**DEPENDABLE  
PRODUCT  
NEWS**  
**TUBELITE®**  
**DEPENDABLE**

Engineering Bulletin: **071801**

Subject: **400CW Enhancement Updates Completion**

**New Outside Captured corner design:**

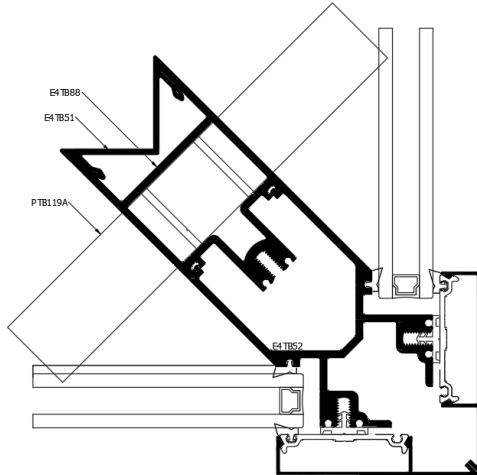
- New back mullion profile – same mullion used for all OS captured, OS SSG and IS SSG
- New head / sill “T” anchor design – same anchor used for all OS captured, OS SSG and IS SSG
- New interior corner closure – profile follows framing
- New exterior covers – eliminated exposed aluminum PP
- Used standard vertical mullion zone dams
- New corner inserts

**New Outside SSG corner design:**

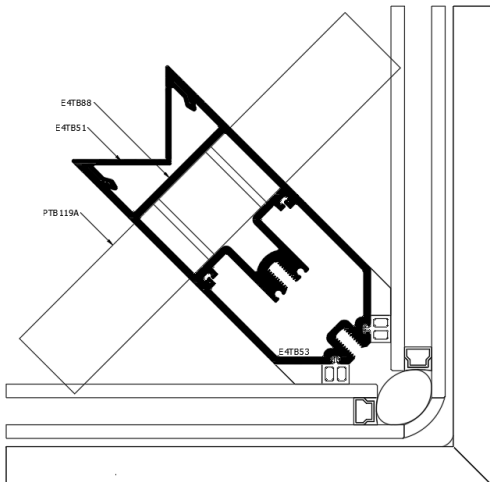
- New back mullion profile – same mullion used for all OS captured, OS SSG and IS SSG
- New head / sill “T” anchor design – same anchor used for all OS captured, OS SSG and IS SSG
- New interior corner closure – profile follows framing
- New zone dams
- New corner inserts

## New Inside SSG corner design:

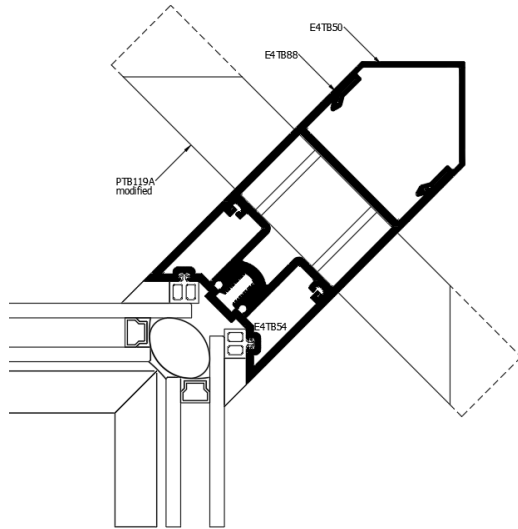
New back mullion profile – same mullion used for all OS captured, OS SSG and IS SSG

New head / sill “T” anchor design – same anchor used for all OS captured, OS SSG and IS SSG

New interior corner closure – profile follows framing

New zone dams

New corner inserts
